CITY OF PORTLAND

City of Portland, Maine - Building or Use Permit Application

Addendum Request

RE: 24' x 24' garage on 43 Bay St, Portland

CHIMNEY DETAILS

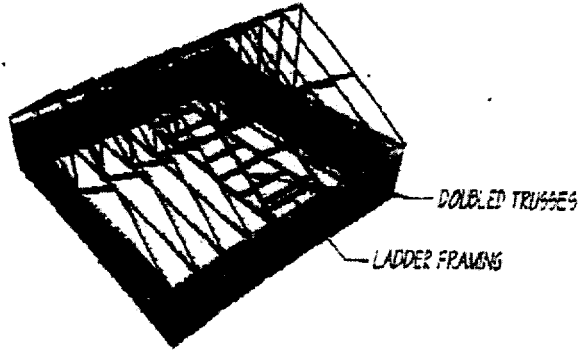
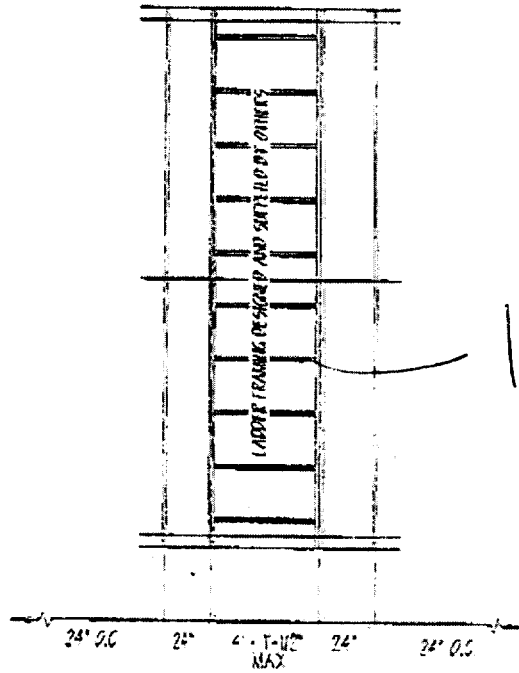
Here is the attachment. This is the layout that woodstructures uses. It is the same as framing in for a chimney. All the ladder sections are the same size lumber as the supporting structure of the truss. The spacing for the ladder sections are 1 foot on center. If you have any questions, give me a call.

Need Spec on Framing at Truss
for Stair opening

Ladder framing is designed, supplied and connected by others

A2410

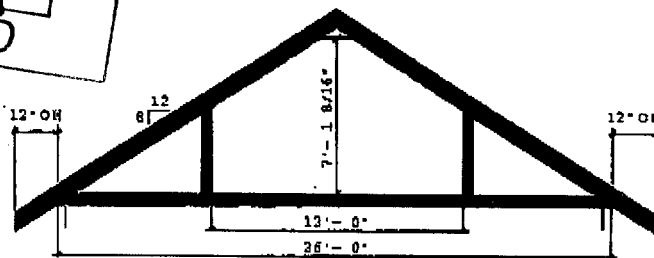
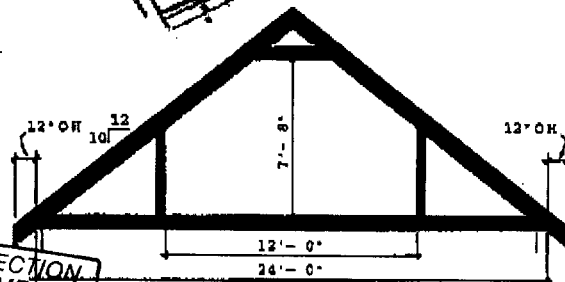
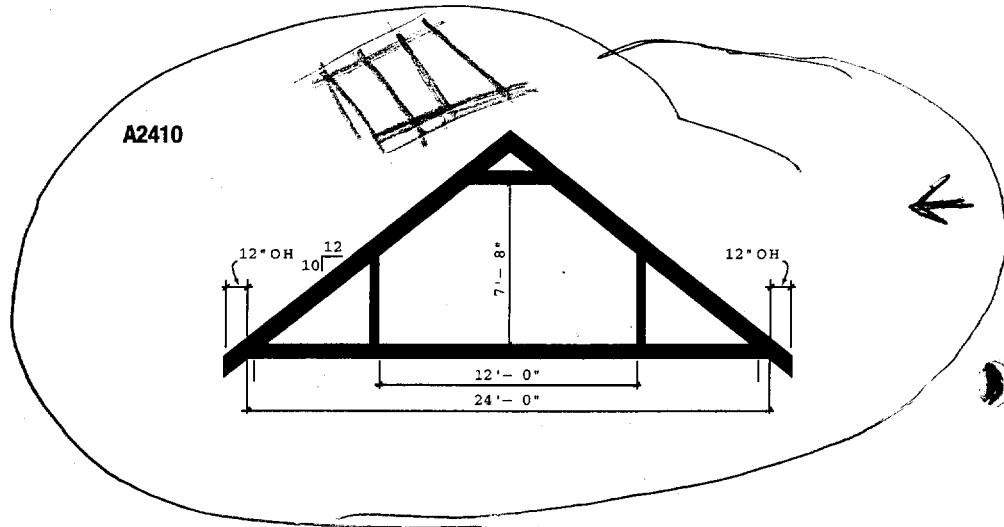
Construction: (pitch at ~~8/12~~ 10/12)

1. Wall studs 2x4 16" on center → must maintain max Ht of 18' to midline
2. Bottom plate- pressure treated 2x4
3. Corner posts 2x4
4. Top plate- double 2x4
5. Attic stock trusses 24" on center for 30 lb live load (see attached sheet for specs)
6. T-111 siding
7. Headers for garage doors 2x8
8. 5/8" CDX Plywood for roof sheathing
9. Metal drip edge all around roof
10. Asphalt roof shingles
11. Floor in loft 5/8" CDX plywood
12. Staircase for access to loft built to code (max 7 ¾" rise and minimum 10" net tread)
13. Graspable handrail for staircase with height minimum of than 34" (staircase to be enclosed by walls on both sides). Landing at bottom of staircase 2'x 2'.

Rafters, rafter ties and joists are being changed to prefabricated trusses as detailed above. This change makes the lally column support and the center beam unnecessary. These items have been deleted from the above materials list and the trusses have been added.
